SUBSURFACE WASTEWATER DISPOSAL SYSTEM APPLICATION

City, Town, or Plantation: Cliff Island
Street or Road: Island Avenue
Subdivision, Lot #: Estate of David Th

Subject: Approval, Replacement System Variance Request, Thompson Estate Property, Island Avenue, Cliff Island, Portland

REPLACEMENT SYSTEM VARIANCE REQUEST

revised Nov 30 2006 jmd

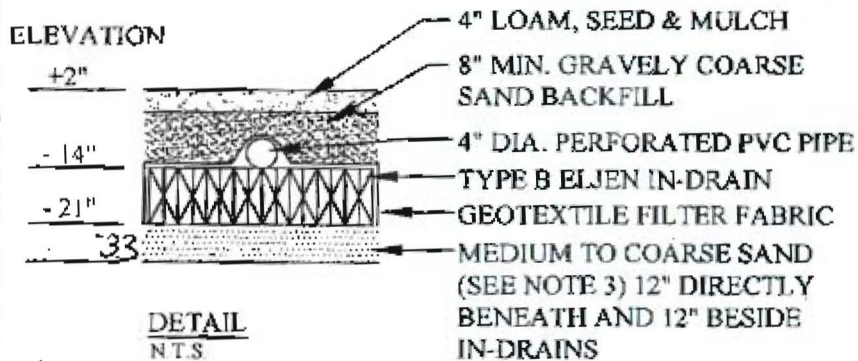
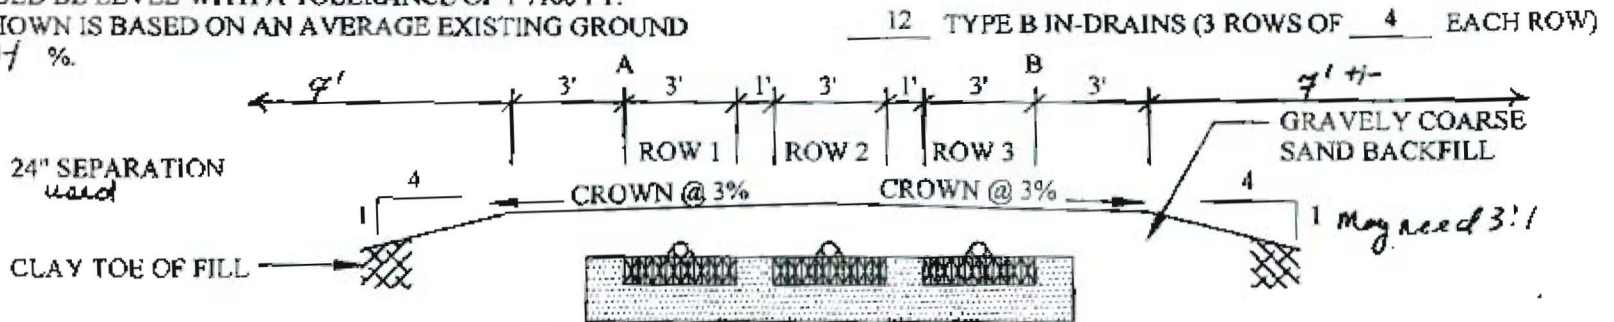
- 1. Prior to issuance of a permit to install the system, the Site Evaluator shall provide the owner and the Local Plumbing Inspector with a revised page 2 and page 4 of the HHE-200 Form, containing the data noted above.

1. FILL REQUIREMENTS VARY GREATLY BECAUSE OF BED LOCATION. CONTRACTOR SHALL FIELD CHECK ALL SLOPES BEFORE DETERMINING ACTUAL FILL REQUIREMENTS.
2. NOTES ON PAGE 4A OF 4 ARE HEREBY MADE PART OF THIS HHE-200 FORM. *Revised No 30-2006*
3. THE FIRST 12" DIRECTLY BENEATH THE IN-DRAINS SHALL BE MEDIUM TO COARSE TEXTURED SAND WITH AN EFFECTIVE SIZE OF 0.25 TO 2.0 mm. NO GREATER THAN 5% PASSING A #200 SIEVE AND NO PARTICLES LARGER THAN 3/4 INCH OR MATERIALS MEETING THE ASTM C-33 SPECIFICATION. CONCRETE OR WASHED SAND IS A RELIABLE CHOICE. SUITABILITY OF BANK RUN SAND OR SITE DISPOSAL AREA SOIL MUST BE VERIFIED.
4. ROTO-TILL ORIGINAL SURFACE THOROUGHLY IN ALL AREAS OF THE SYSTEM INCLUDING FILL EXTENSIONS BEFORE PLACING FILL. REMOVE ALL ORGANIC LAYER IN AREA OF SYSTEM.
5. ROWS SHOULD BE LEVEL WITH A TOLERANCE OF 1"/100 FT.
6. SECTION SHOWN IS BASED ON AN AVERAGE EXISTING GROUND SLOPE OF 0%.

BOTTOM OF BED = -27

Revision

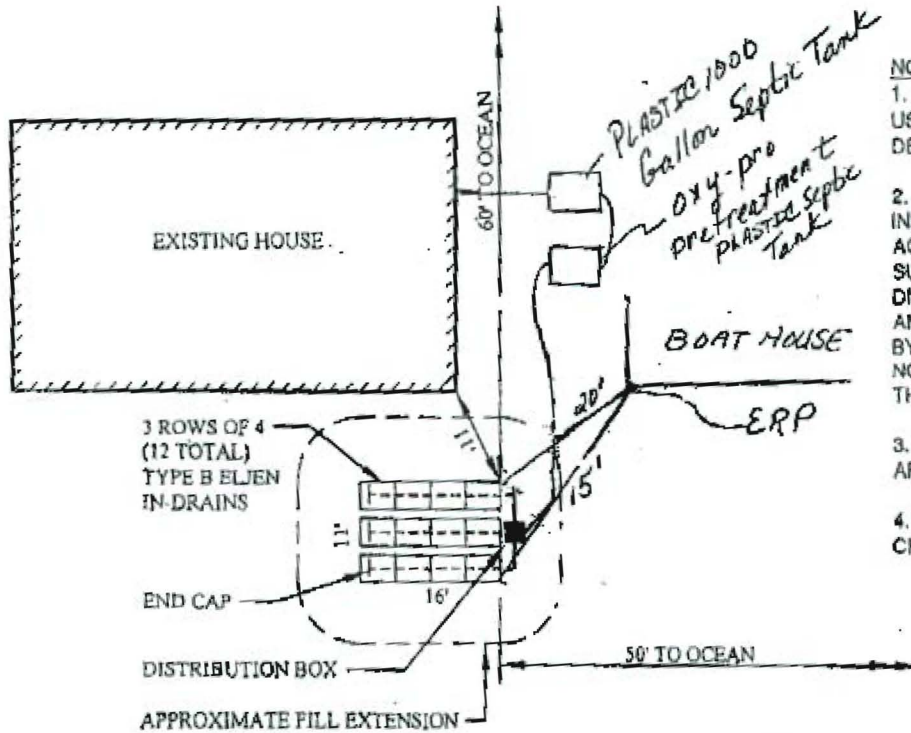
Aug 15 2008
Date
Revised Oct 22 2008
Boat House location
